ADDENDUM NO. 1

**VA SORCC
REPLACE B248 CHAPLAIN SERVICE**

July 20, 2015

Item 13- Drawing A 5.5 Exterior Details (Revision 1)

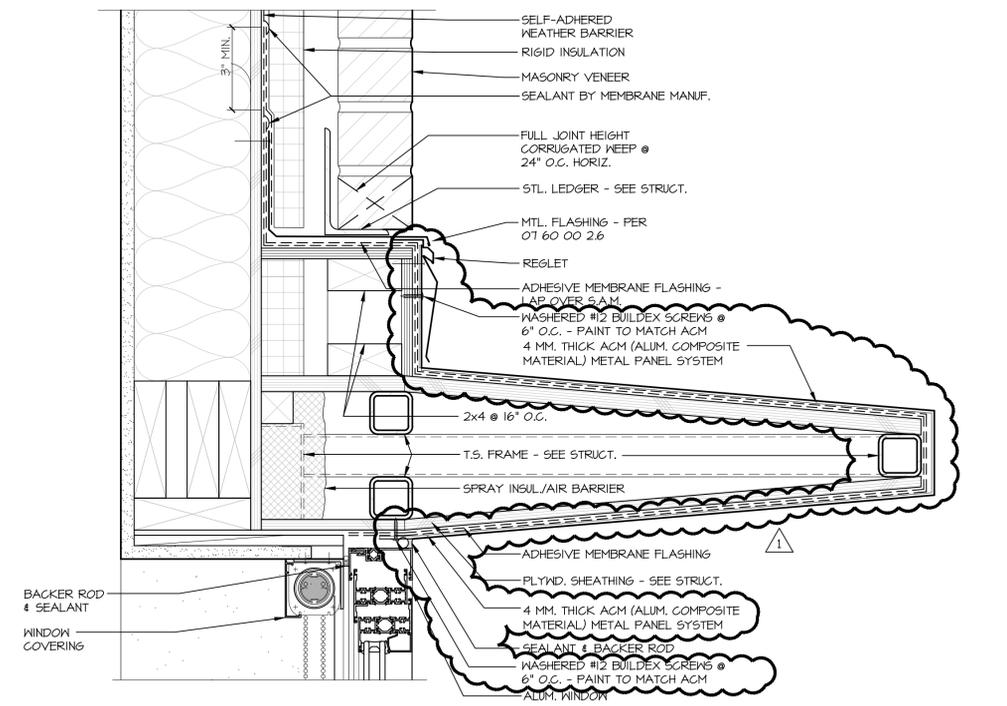
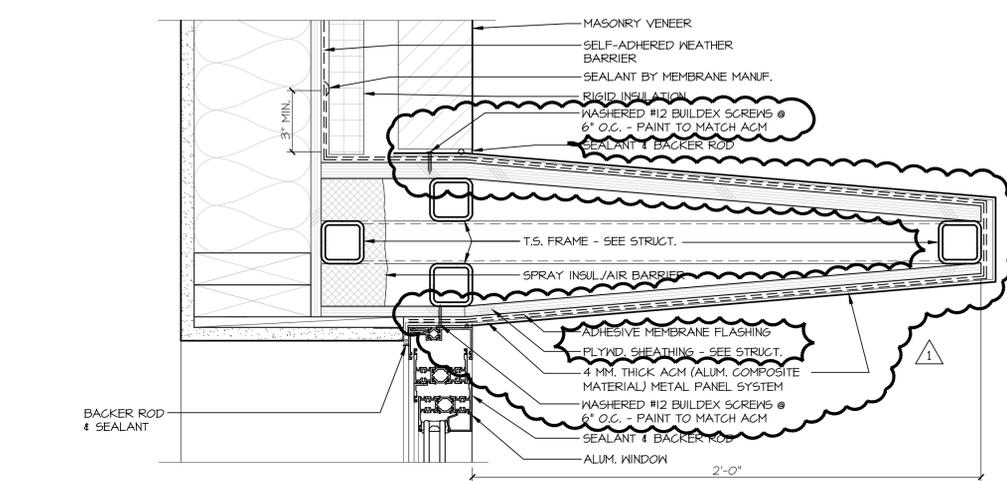
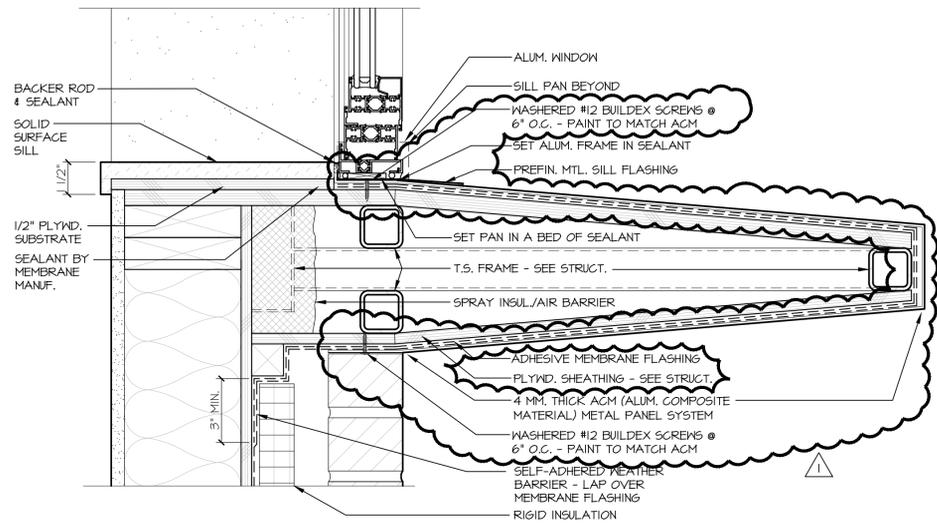
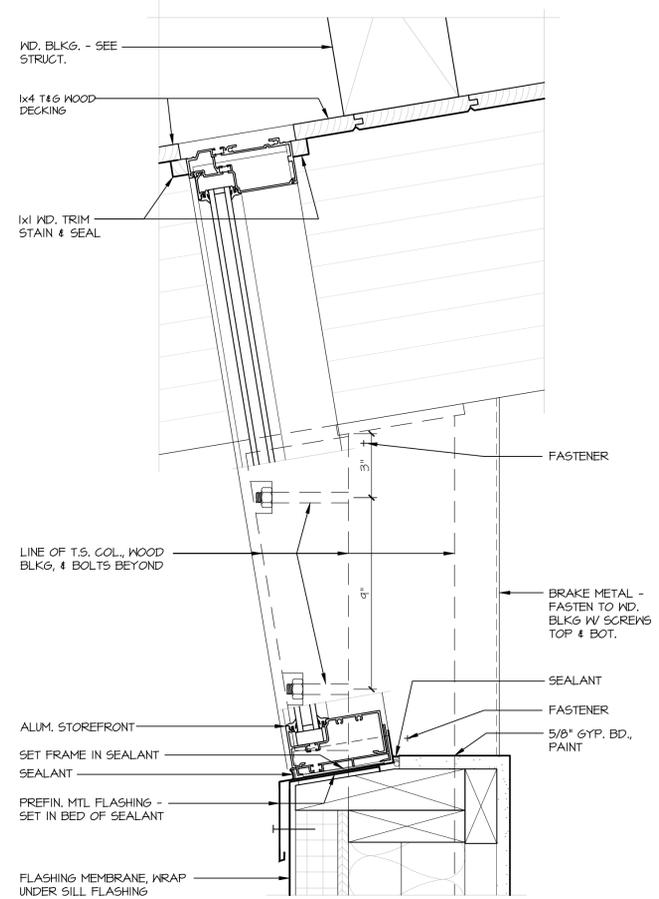
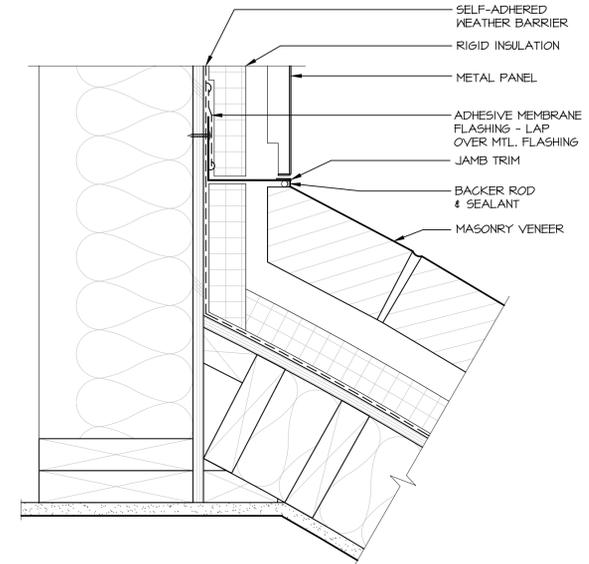
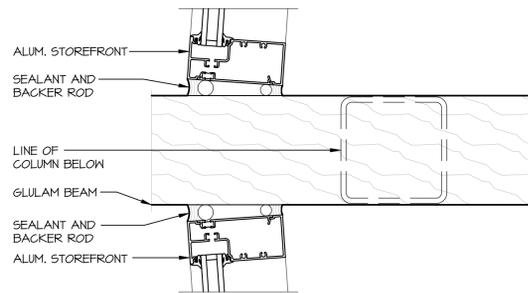
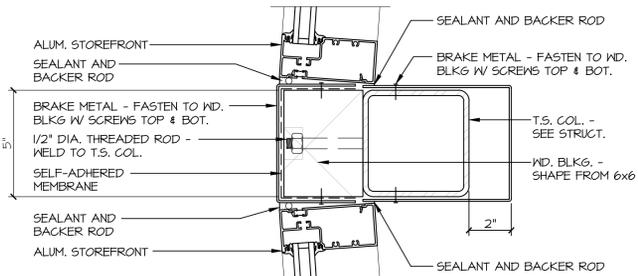
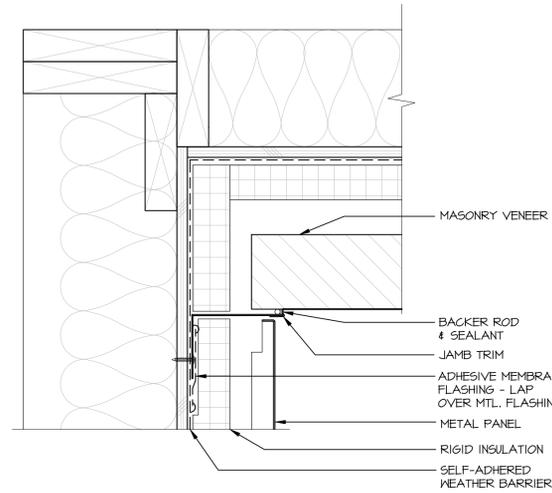
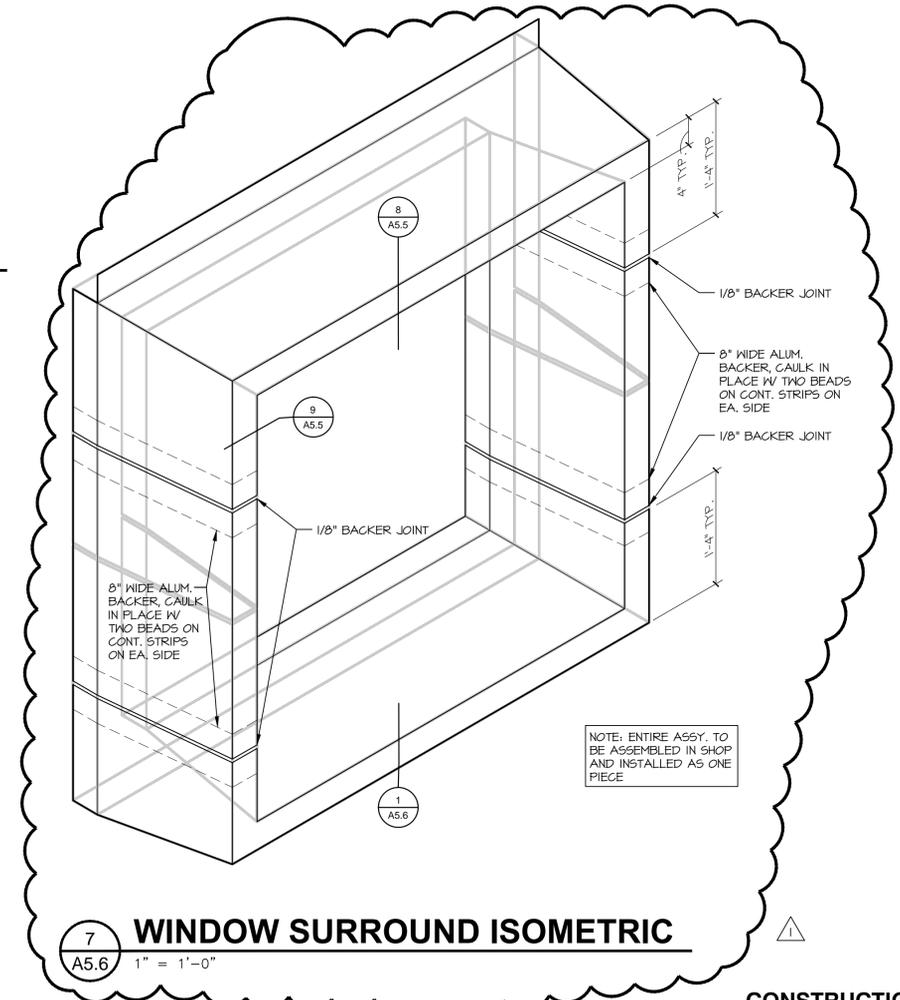
Item 2-Window Sunshades: The metal sunshade surrounds to the windows on the South side have been revised. They will be fabricated from Composite Metal Panels as described in Section 07 60 00 FLASHING AND SHEET METAL. See Addendum Item 8. The details have been revised and can be found in revised drawings A5.5 and A5.6 (attached to this Addendum)

Replace Drawing A5.5 with the revised sheet attached to this Addendum

NEW TEMPORARY WALL at EXIST. CHAPEL

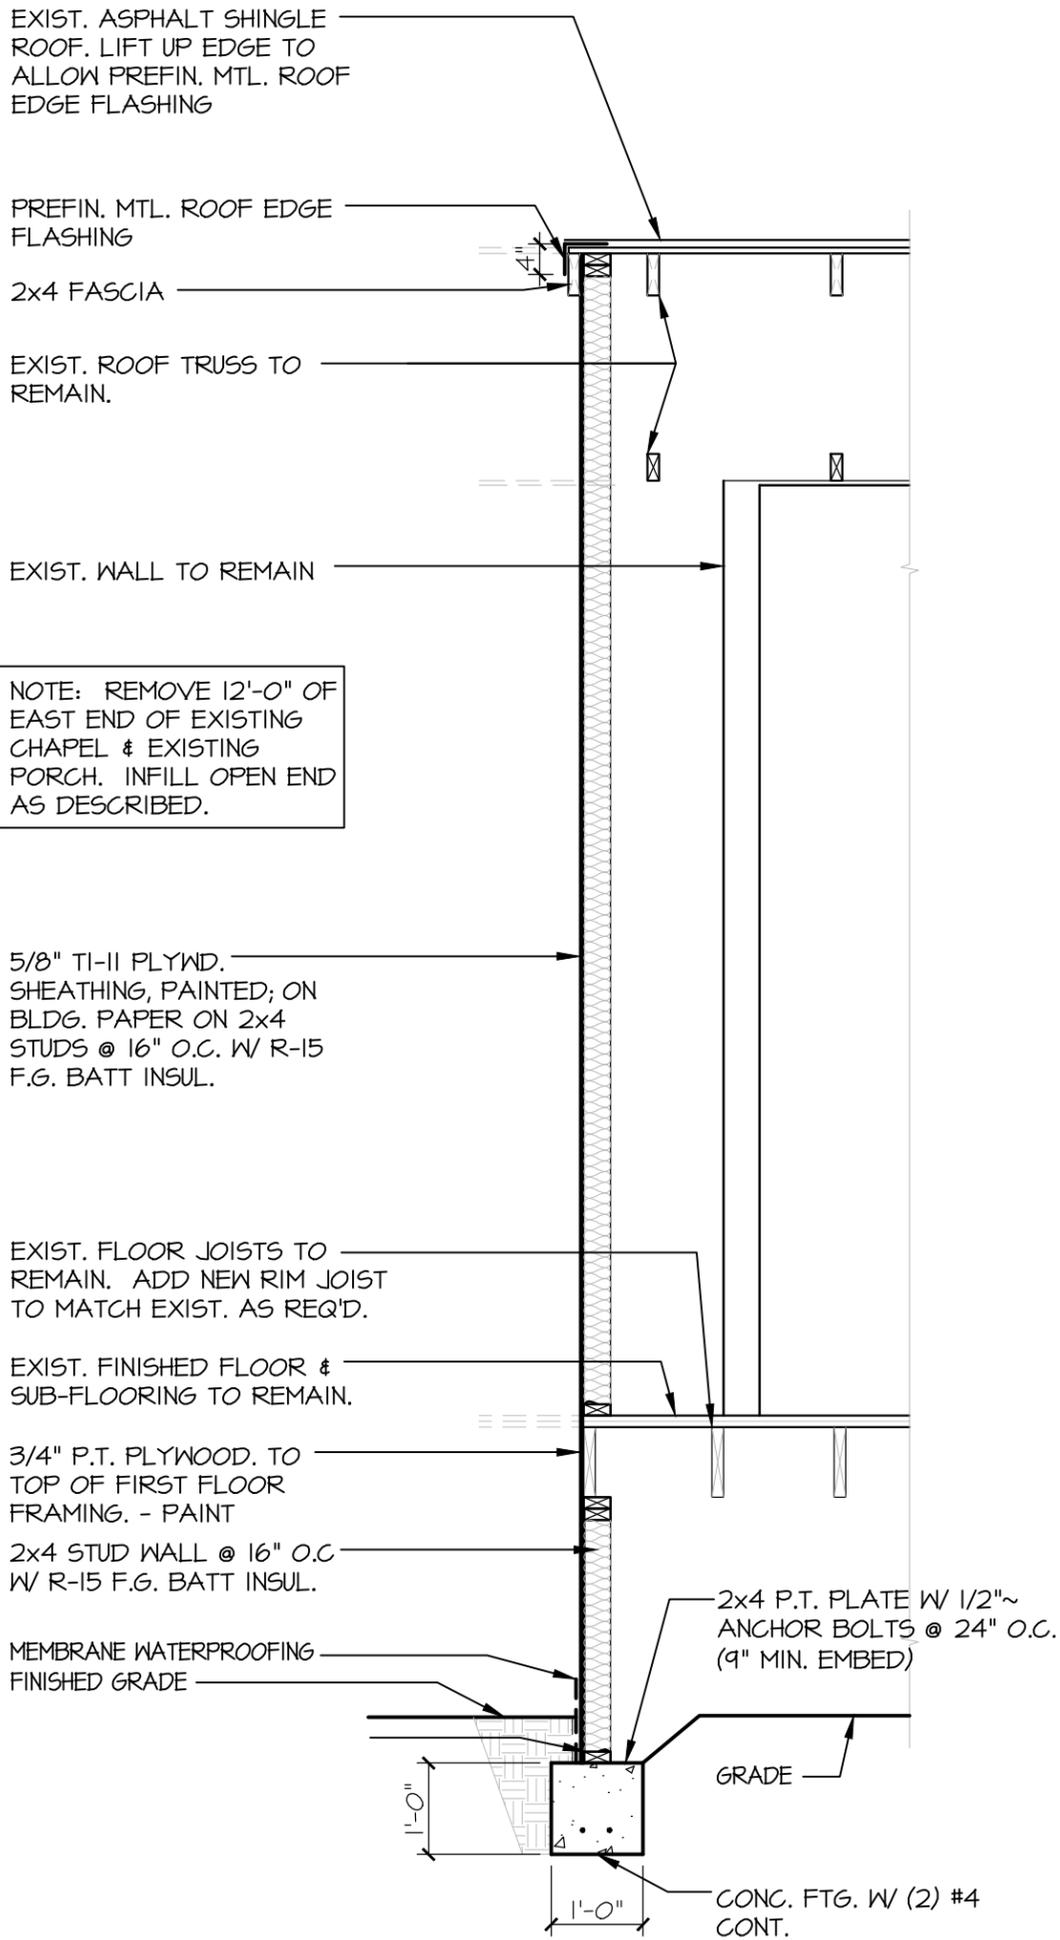
Drawing SD-1 (attached) describes the temporary end wall of the chapel after the East 12 feet of the building is removed

1. The existing Chapel shall remain operational until the new Chapel is ready for occupancy.
 - a. Provide safe entry into the existing building at all times.
2. Partial demolition of the East end of the existing building will be accomplished prior to the start of the Chapel construction. Refer to drawing SD-1 for temporary end wall of Chapel
3. The concrete sidewalk bordering Veterans Memorial Drive will be construction prior to the start of the construction of the Chapel building.
 - a. Protect the sidewalk from damage during the course of construction
 - b. Any damaged portions of the sidewalk to be replaced at no cost to the VA.
 - c. Place the construction fence so the public has access to the sidewalk.”

SIDEWALK BASE BID

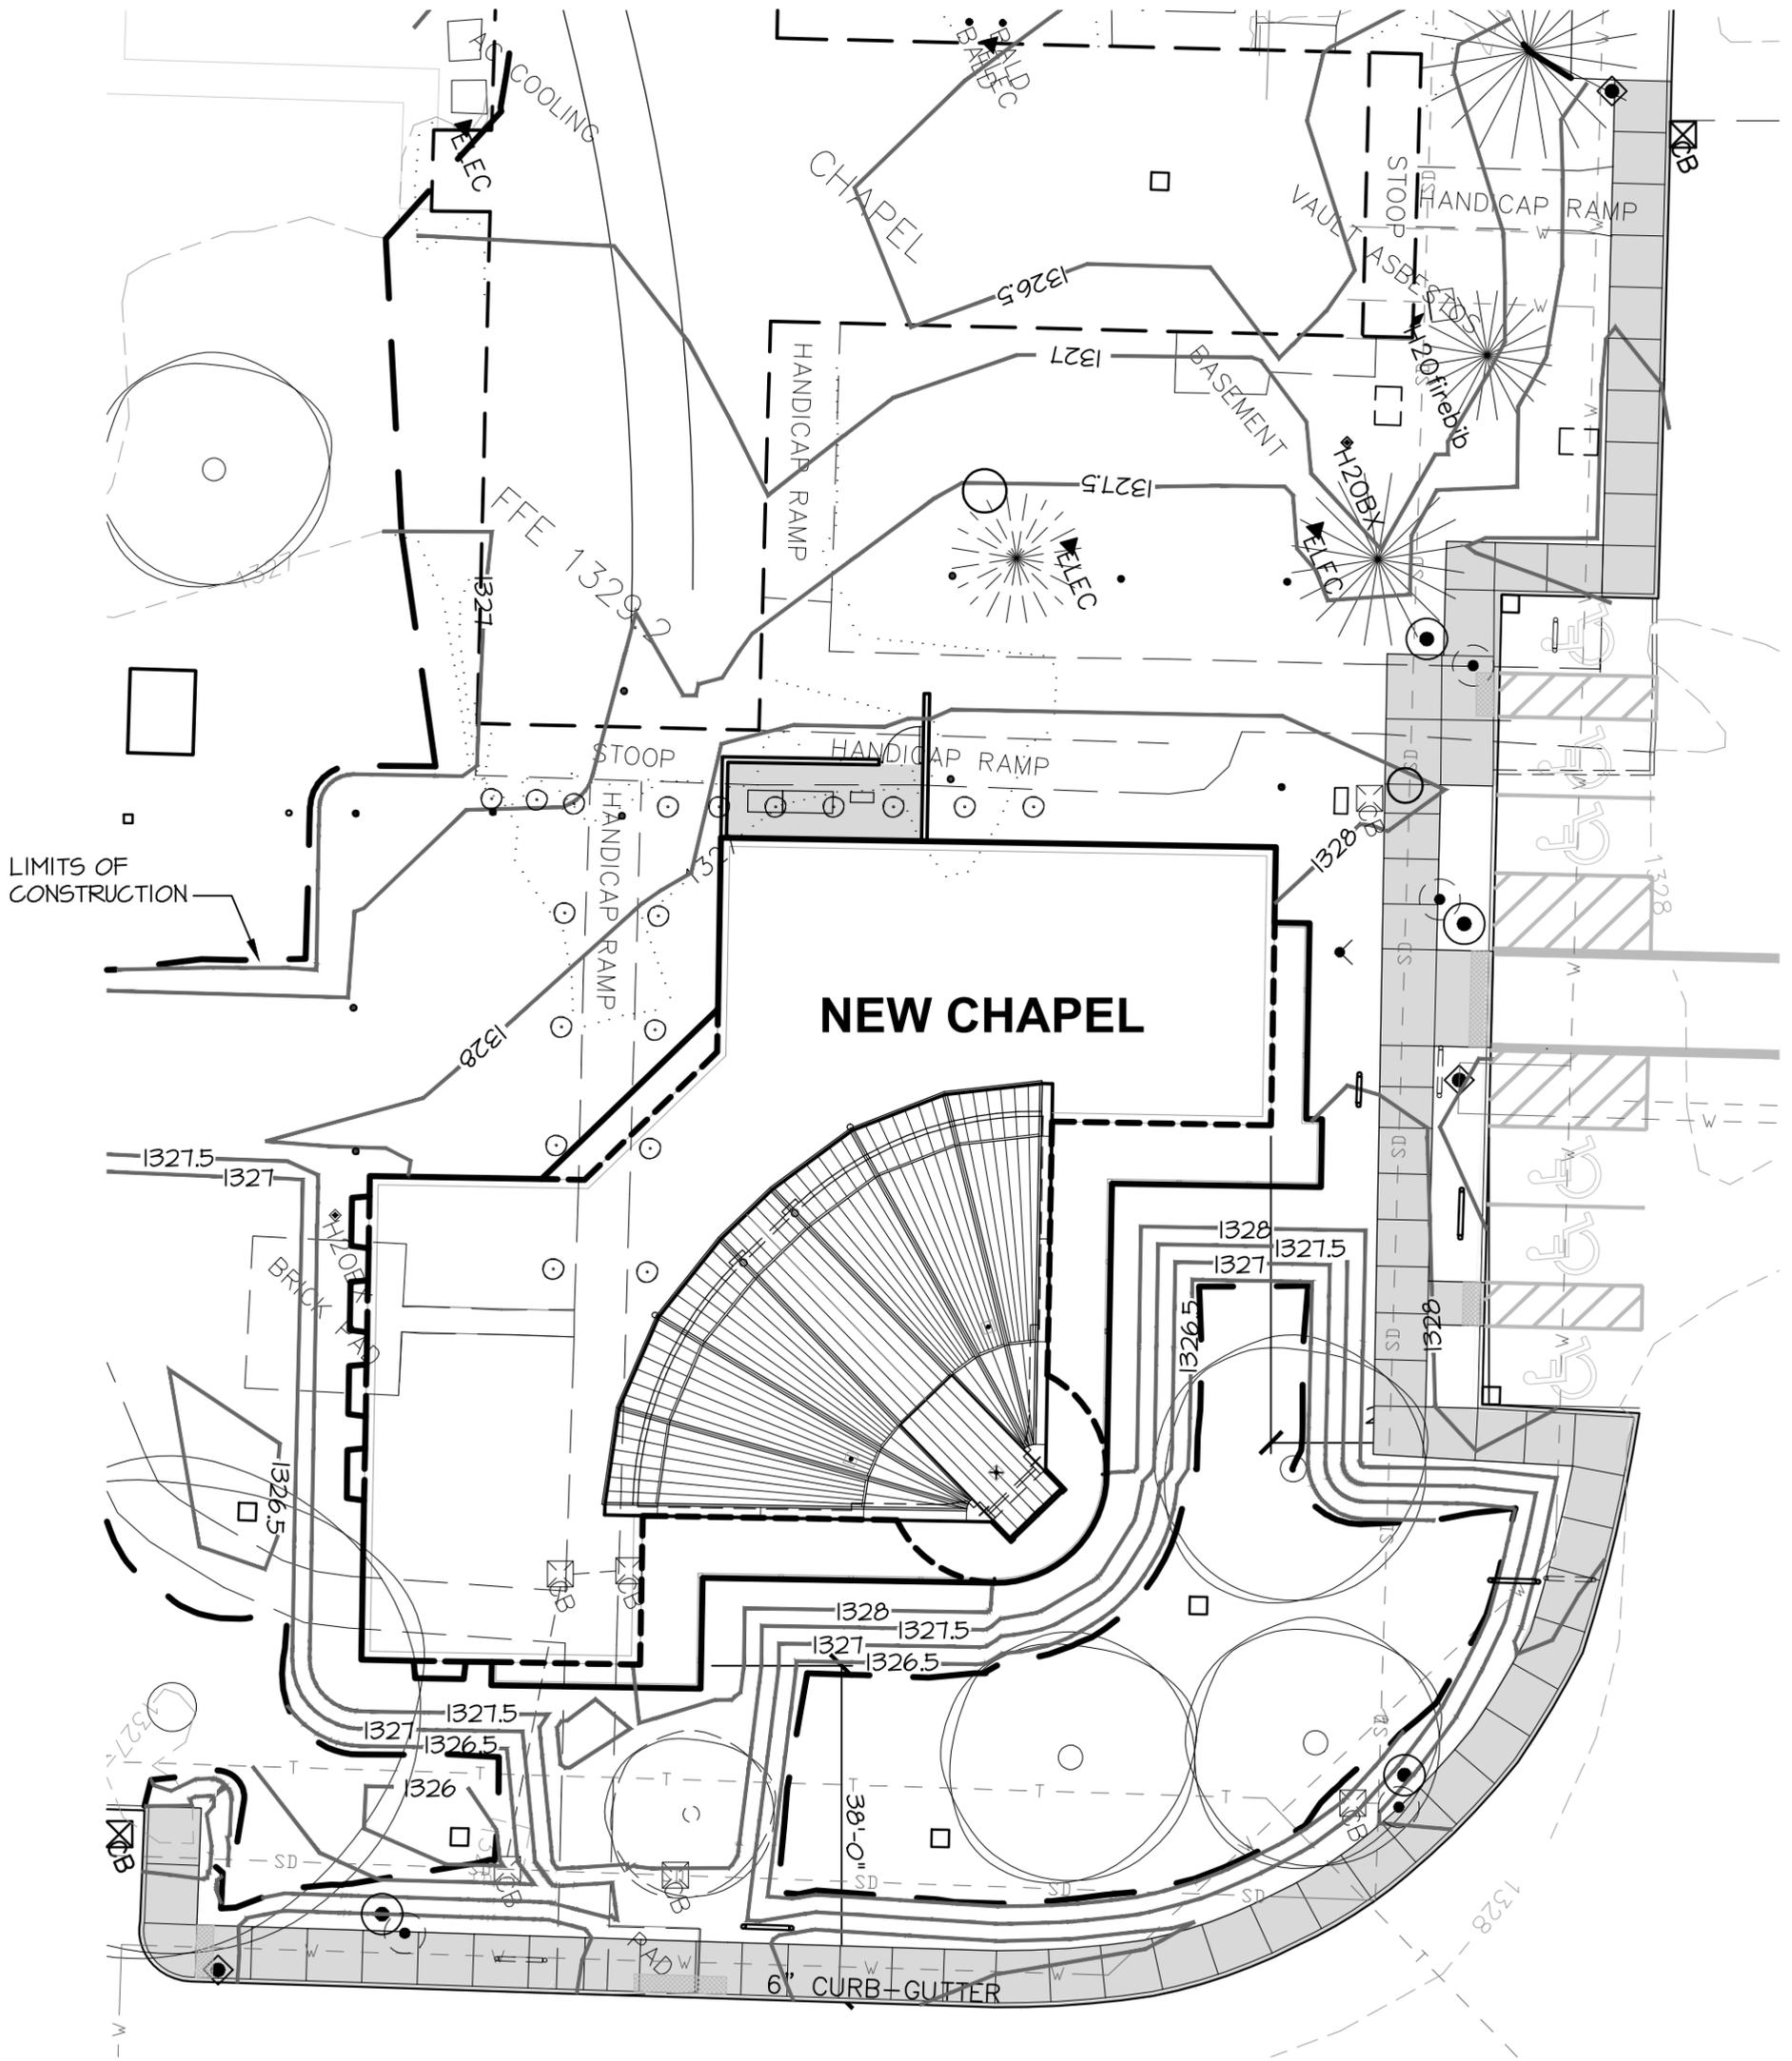
Item 1-Phasing and the Concrete Sidewalk: See the revised Phasing language in Item of this Addendum. The sidewalk as indicated in Drawing SD-2 (attached to this Addendum) indicates the sidewalk that is to be installed if the Alternate is exercised. The sidewalk along Veterans Memorial Drive is to be installed prior to the start of construction and the construction fence shall be placed as to allow this sidewalk to be used at all times during construction.

Drawing SD-2 (attached) describes the sidewalk that will be part of the base bid if Alternate No. 4 is exercised

D. BID ITEM NO. 5 (ALTERNATE No. 4): The same as BID ITEM No. 4 except delete sidewalks and flat concrete work as indicated on the drawings. See SD-2 for extent of sidewalk to remain in base bid if alternate is exercised. Do not install bollard lights type S; install conduit only. Do not install existing salvaged steeple and turn over to VA.
